**Amendment No. 2 to Subsidence Management Plan for No. 3070 Remembrance Drive due to shortening of LW S4A**

Please be advised that a minor amendment can be made to the Management Plan, which is titled *MSEC1193-15 SIMEC Mining – Tahmoor South Longwalls S1A to S6A – Management Plan for potential impacts to Tahmoor Garden Centre, 3070 Remembrance Drive, Bargo, Revision C*.

Suite 402, 13 Spring Street, Chatswood NSW 2067 PO Box 302, Chatswood NSW 2057 Tel +61 2 9413 3777 www.minesubsidence.com	
		<b>TAHMOOR SOUTH MODIFICATION - LWS4A GENERAL LAYOUT</b>	
DATE:	SCALE:	DRAWING No:	Rev No
20 Aug 2024	as shown	MSEC1446-01	01

Drawing No. MSEC1446-01

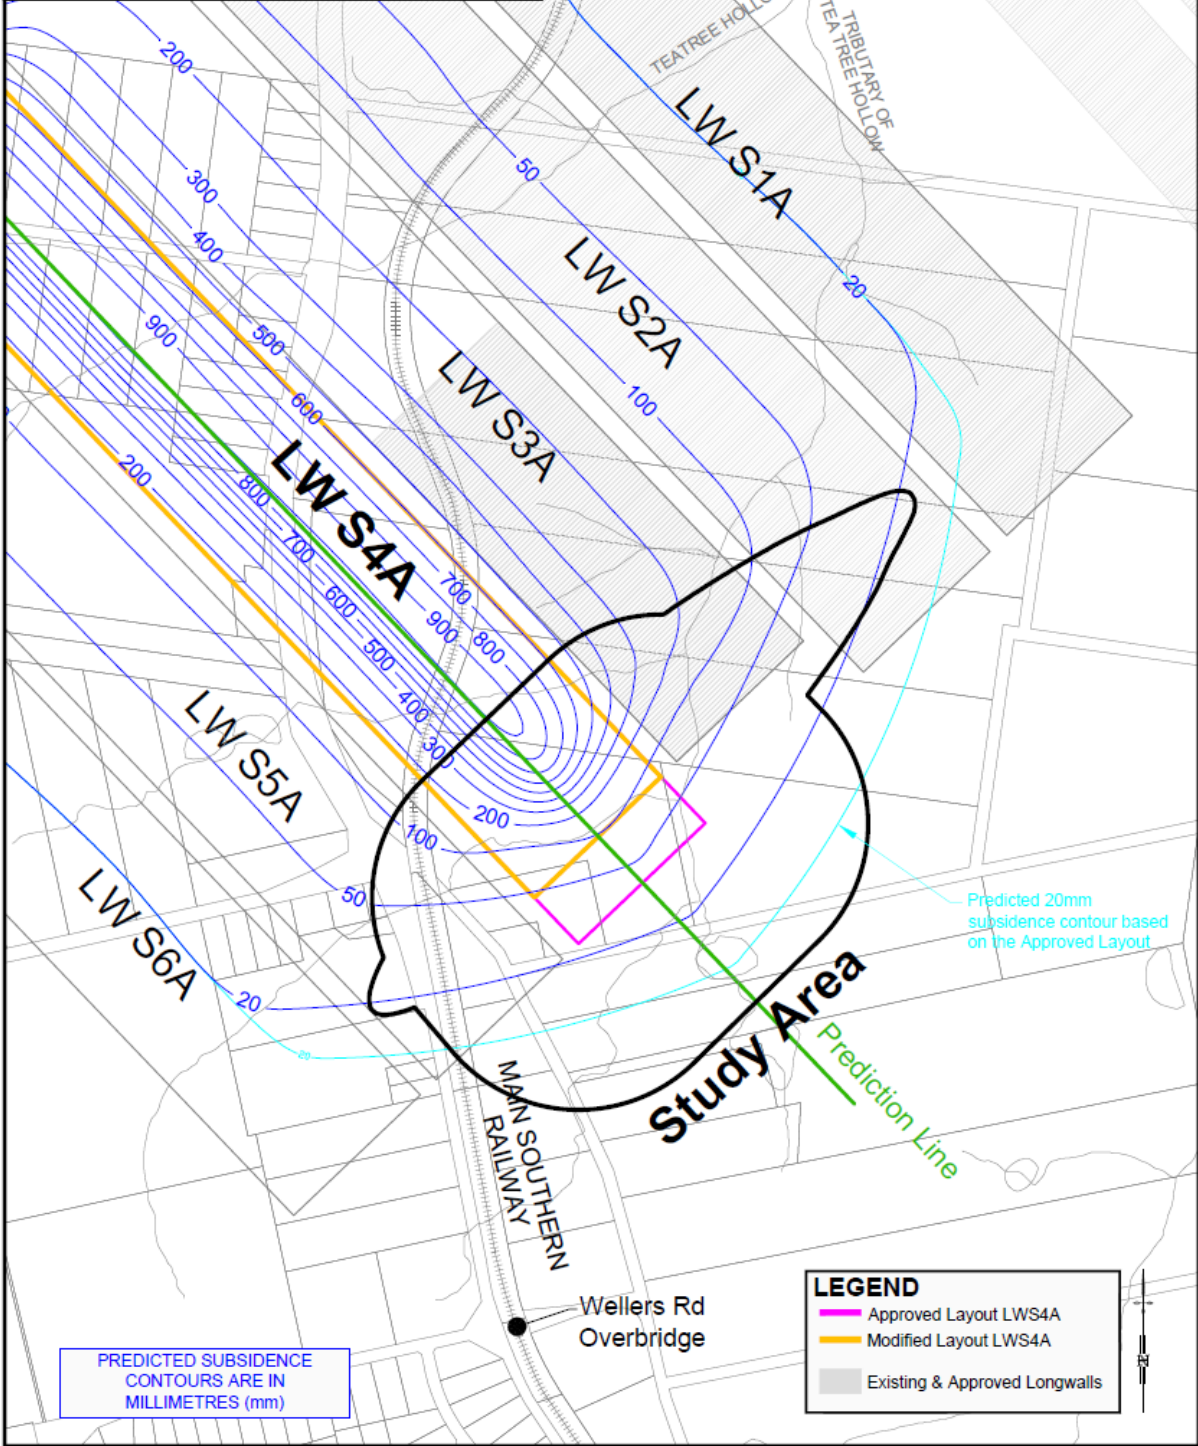
Tahmoor Coal has shortened LW S4A by approximately 104 metres at the commencing end, as shown in Drawing No. MSEC1446-01. The change will have a negligible effect on the amount and extent of subsidence that will be experienced at No. 3070 Remembrance Drive, as shown in Drawing No. MSEC1446-07.
